Docket Number:	17-HYD-02
Project Title:	Hydrogen Station Network Future Approaches
TN #:	222048
Document Title:	ITM Power, Inc. Comments On Hydrogen Refueling Station Technical Requirements (2 of 2)
Description:	N/A
Filer:	System
Organization:	ITM Power, Inc.
Submitter Role:	Public
Submission Date:	12/22/2017 2:56:43 PM
Docketed Date:	12/22/2017

On Hydrogen Refueling Station Technical Requirements (2 of 2)

SUMMARY OF PROPOSED CHANGES

Fueling Position Example Diagram

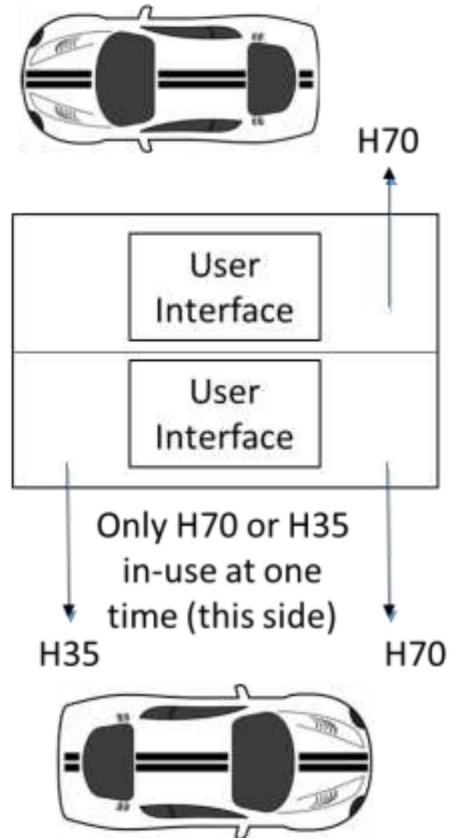
A station in a "cluster" area shall have a minimum of 2 fueling positions. A "connector" or "destination" station may install only 1 fueling position, but the site layout shall not preclude the future addition of a second fueling position.

A single fueling position is defined as an H70 fueling interface with a dedicated customer vehicle access, user control, and point of sale interface. The fueling position may also include an H35 nozzle, in addition to, the H70 nozzle. For a station with multiple fueling positions, each fueling position shall be capable to operate independently and in-parallel (simultaneously).

[see enclosed diagram below]

Each fueling position station shall have the capability to dispense a minimum average daily capacity of no less than ~~160~~ 180 kg. Applicants will be required to adhere to the minimum daily fueling capacity proposed in their application. Minimum daily fueling capacity refers to the station's capacity to fuel light duty vehicles over a 12-hour period, between 6 a.m. and 6 p.m. on a daily basis.

Each fueling position shall have the capability to dispense a minimum of 200 kg over a period of 24-hours (6 a.m. to 6 a.m.) on a daily basis. Stations which require a batch process such as resupply from delivered gas, or recovery period for production or compression processes, must include the delay caused by this process step over the 24-hour period. The 24-hour fueling capacity shall also represent a repeatable value such that fueling could occur on consecutive days between periods of planned maintenance.
